APPLICATION NO.	FILING DATE	FIRST NAMED INVENTOR	ATTORNEY DOCKET NO.	CONFIRMATION NO.
09/347,845	09/30/1999	YI YANG	243/079	4401

Office Action Summary	Application No. 09/347,845	Applicant(s) YANG ET AL.	
	Examiner Vy Q. Bui	Art Unit 3731

DETAILED ACTION

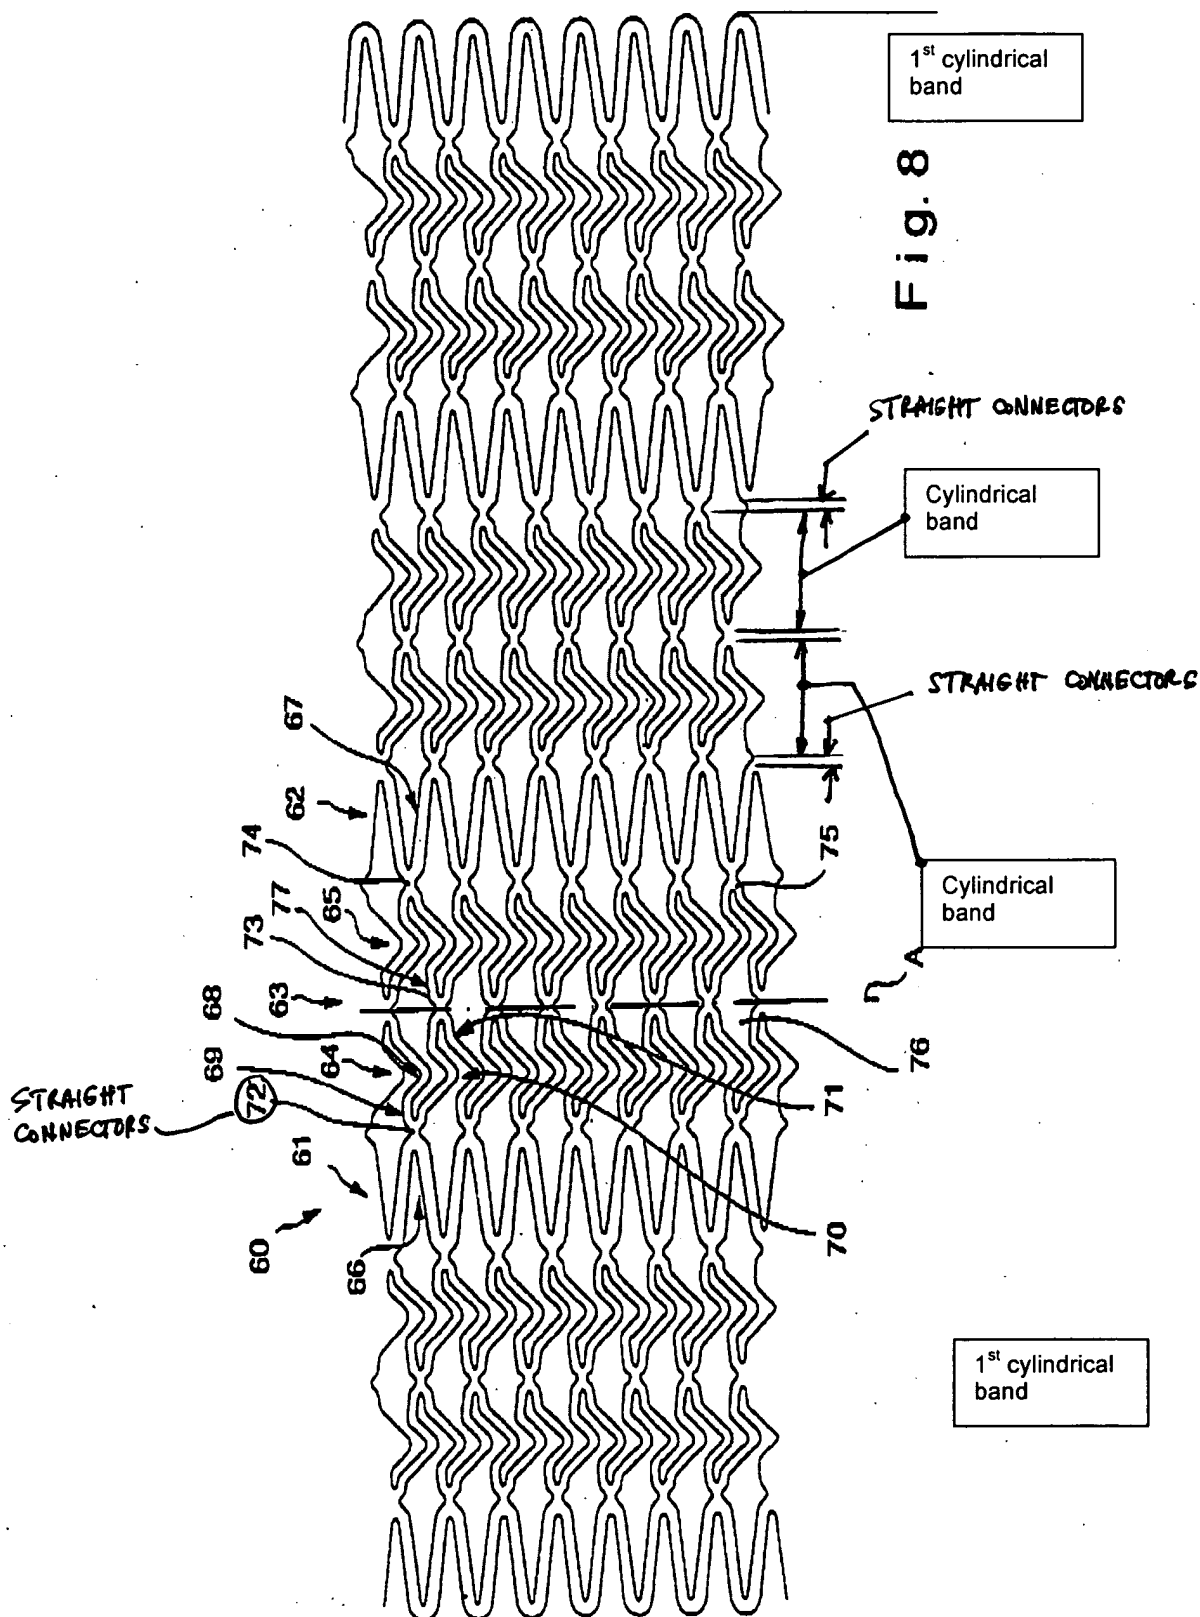
- **A central portion consists essentially of a series of cylindrical bands, each band comprises a generally non-sinusoidal zigzag pattern of diagonal elements having generally arcuate shapes, arbitrarily assigned either a clockwise or counter clockwise orientation (please, see Von Oepen's Fig. 8 reproduced on page 5).**

- A plurality of straight and short (72)
- The short longitudinal connectors (72) have a longitudinal dimension substantially smaller than a longitudinal dimension of the diagonal elements (as recited in claim 9).
The diagonal elements comprise 1st and 2nd generally straight portions having 1st ends connected to preceeding and succeeding diagonal elements and 2nd ends being connected together (as recited in claim 10).
- The diagonal elements of each cylindrical band are out of phase with any adjacent cylindrical band (as recited in claim 11).

As to claims 12-15 and 17-22, VON OEPEN (Fig. 8 as reproduced and shown on page 5 of this paper; see column 1, lines 36-39, VON OEPEN) discloses a tubular stent (60) comprising:

- A central portion consist essentially of a plurality of bat-shaped cells formed from **non-sinusoidal** cylindrical bands each cell having a head region, a tail region and opposing curved wing regions. The central portion consists essentially of a plurality of bat-shaped cells because all cells are bat-shaped cells in the central portion.
- A plurality of **straight short (72)** extending substantially parallel to a longitudinal axis (as recited in claims 12 and 15)
- The head and tail regions are aligned about the circumference of the stent, the wing regions have a generally V-shaped extending longitudinally away from the head and tail regions (as recited in claim 13).
- The cells are arranged sequentially about the circumference, thereby defining a cylindrical band (as recited in claim 14).

- The wing regions are defined by 1st and 2nd arcuate members, the 1st and 2nd arcuate members comprising a pair of generally straight portions connected to one another by a curved portion, and the curved portion defines an apex of the "V" shape curved wing regions, the apices all pointing substantially in a single direction (as recited in claims 17-18).

- The head regions and tail regions are defined by longitudinal connectors (I-shaped connectors), one of the straight portions of each of the first and second arcuate members is substantially shorter than the other generally straight portion of the respective arcuate member, and the longitudinal connectors define the tail region also define the head region of an adjacent cell (as recited in claims 19-21).

- The connectors comprise a longitudinal connector (V-shaped connector) extending between a wing region of a first cell and a wing region of an adjacent cell (as recited in claim 22).

The claims as filed in the amendment on 12/29/2005 under 37 CFR 1.131 have been carefully considered. Notice that connectors 72 are straight and parallel to the longitudinal axis of the stent in either an unexpanded or expanded position, therefore, the claims are still read on Von Oepen-'747 (F. 8, for example) as indicated in the above rejection.
